GLOBAL SAFETY FIELD INVESTIGATIONS  
DCS4952  
URGENT - DISTRIBUTE IMMEDIATELY

Subject: N182201852 - Service Update  
Navigation Map SD Card Does Not Read

Models: 2019 Chevrolet Silverado 1500 (New Model)  
2019 GMC Sierra 1500 (New Model)

## N182201852 - Navigation Map SD Card Does Not Read

5207511

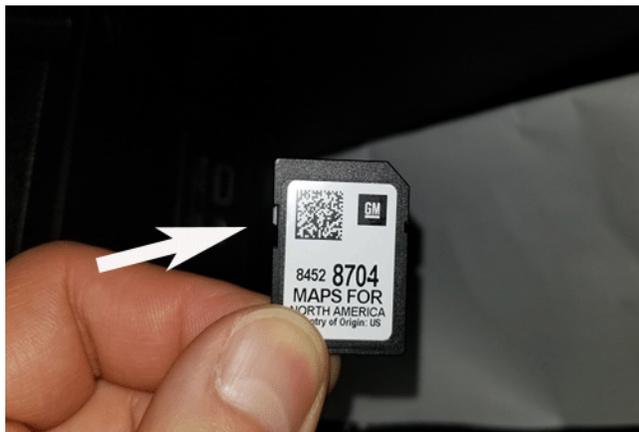
**Note:** When inserting the SD card, make sure that the switch is in the correct position (UP). Insert the card straight and not on an angle, since the switch may rub on the side of the card slot and change position.

**Correct** switch position (up)

5207515

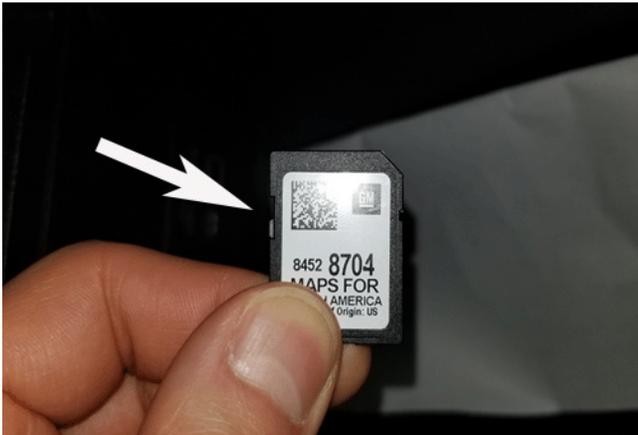
**Incorrect** switch position (down)
